## 7.6 All Other Instrumentation Systems Required for Safety

The information in this section of the reference ABWR DCD, including all subsections, tables, and figures, is incorporated by reference with the following departures and supplements.

Figure 7.6-4a Basic Configuration of a Typical Neutron Monitoring System Division

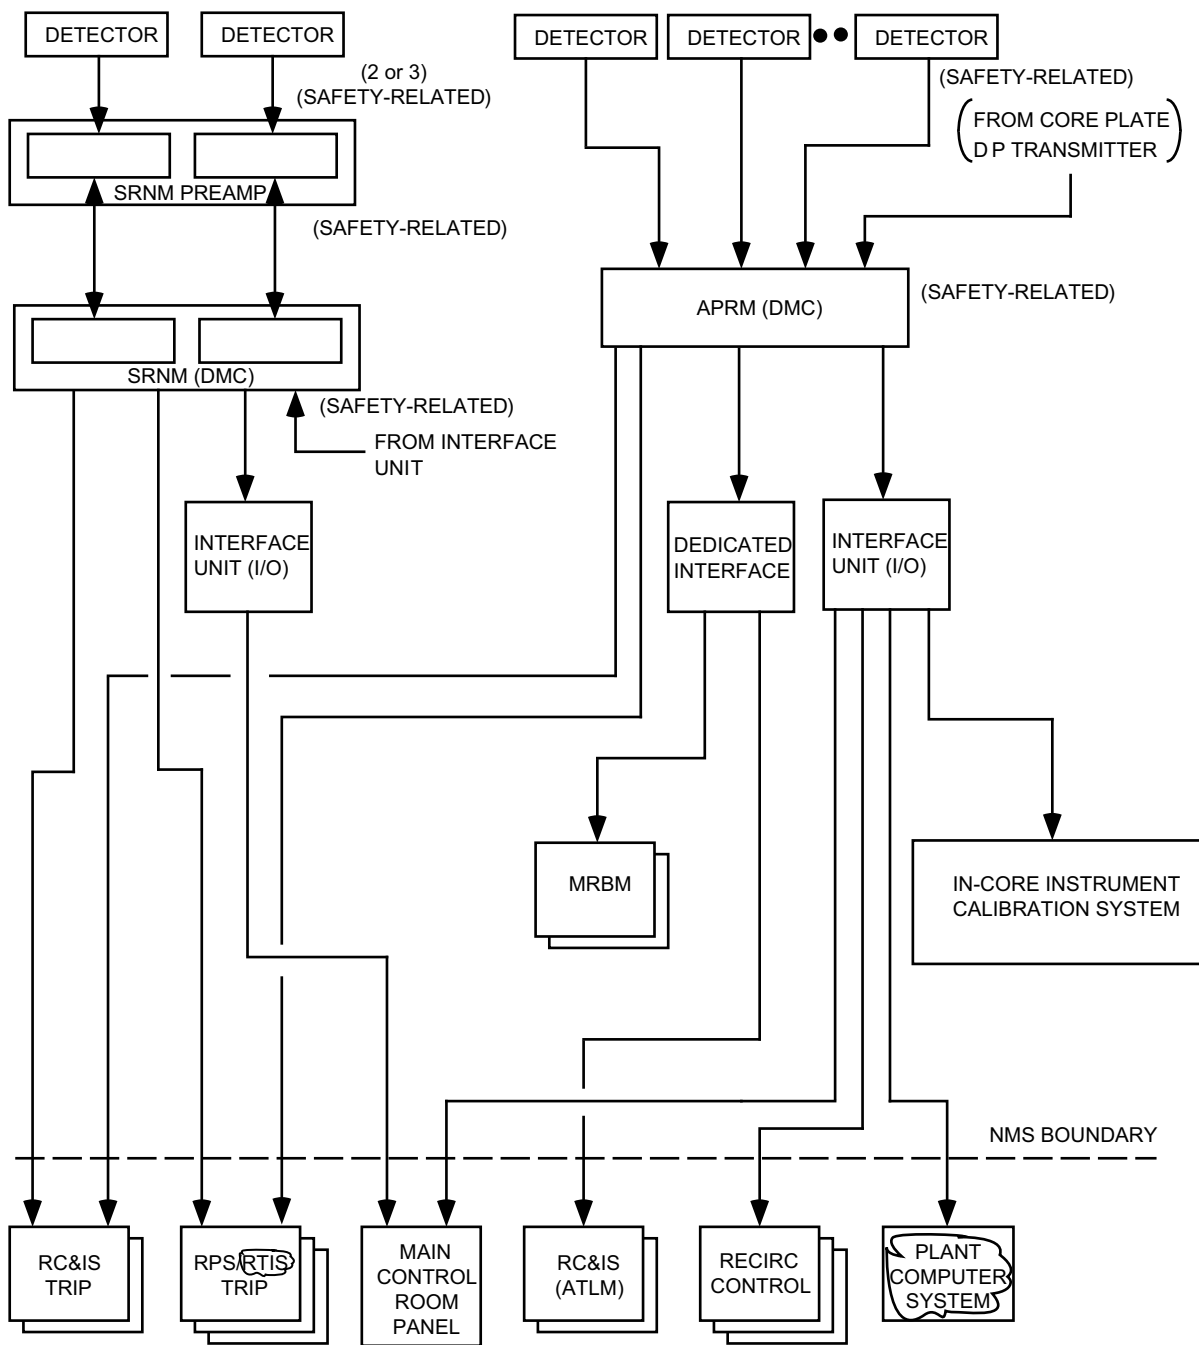
STD DEP T1 3.4-1 (Table 7.6-5 and Figures 7.6-1, 7.6-2, 7.6-4a)

*The purpose of the Neutron Monitoring System (NMS) is to monitor power generation and, for the safety function part of the NMS, to provide trip signals to the Reactor Protection System (RPS) to initiate reactor scram under excessive neutron flux (and power) increase condition (high level) or neutron flux fast rising (short period) condition. The NMS also provides power information of operation and control of the reactor to the Plant ~~Process Computer System (PCS)~~ Functions (PCF) and the rod block monitor. A block diagram showing a typical NMS division is shown in Figure 7.6-4a. The operating ranges of the various detectors are shown in Figure 7.6-4b.*

Figure 7.6-9 Instrumentation Location Definition for the Suppression Pool Temperature Monitoring System

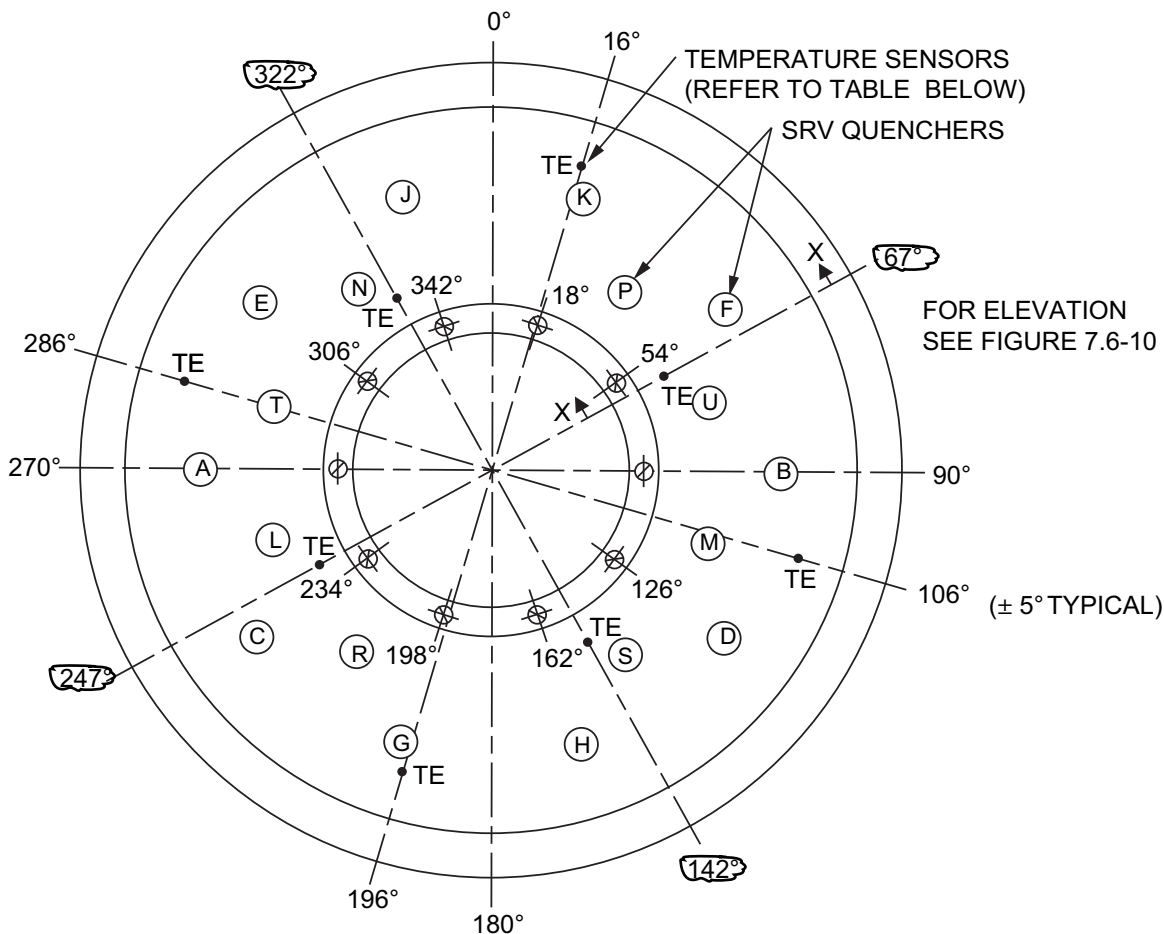
STD DEP 7.6-3 (Figures 7.6-9, 7.6-11, 7.6-12)

The SPTM System configuration is shown in Figures 7.6-9 and 7.6-10. There are eight temperature circumferential sensor locations (Figure 7.6-9), which are chosen based upon the following considerations:

- (2) Each SRV discharge line quencher is in direct sight of two sets of temperature sensors within 9 meters.

Figure 7.6-14 OPRM Logic

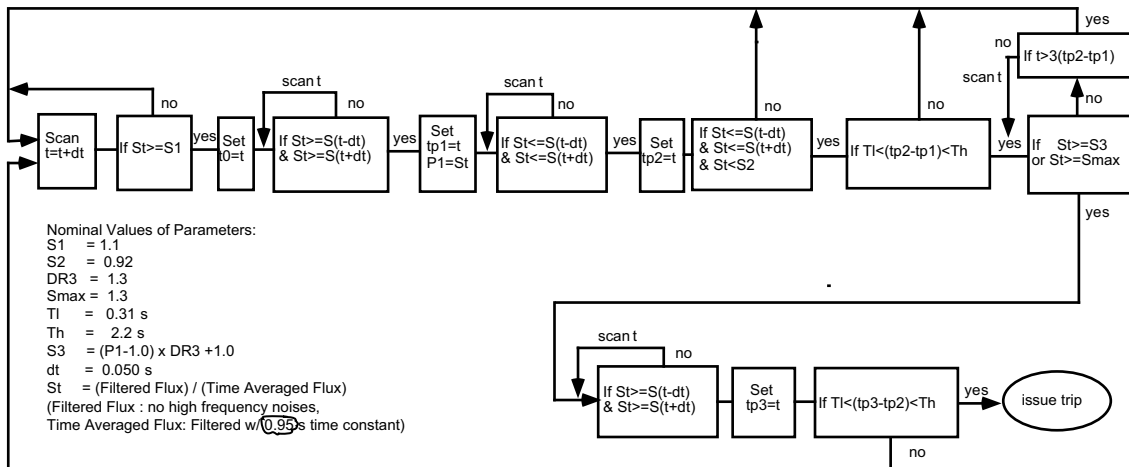
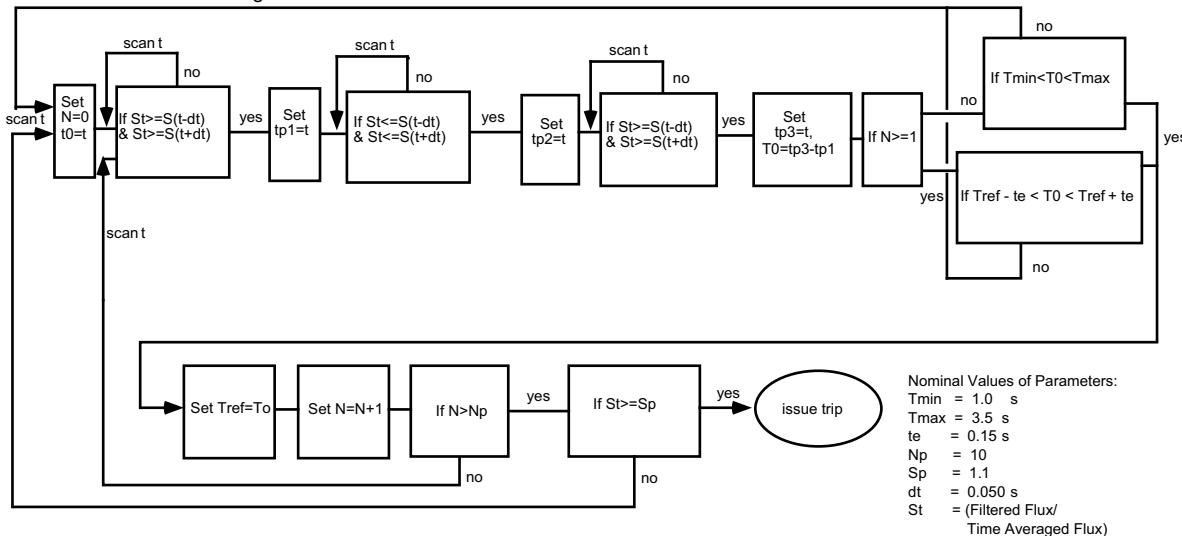
STD DEP 7.6-1 (Table 7.6-2 and Figures 7.6-2, 7.6-14)

~~For the OPRM trip function, the response signal of any one OPRM cell that satisfies the conditions and criteria of the trip algorithm will cause a trip of the associated OPRM channel. Figure 7.6-14 illustrates the trip algorithm logic. The OPRM trip function does not have its own inoperative trip for insufficient number of total LPRM inputs in the channel. It follows the APRM's inoperative trip of insufficient number of LPRMs.~~ The OPRM function has its own inoperative trip when the channel has less than the required minimum operable cells, or there is an OPRM self-test fault, or the APRM instrument firmware/software timer has timed out, if there is a loss of power to the APRM instrument.
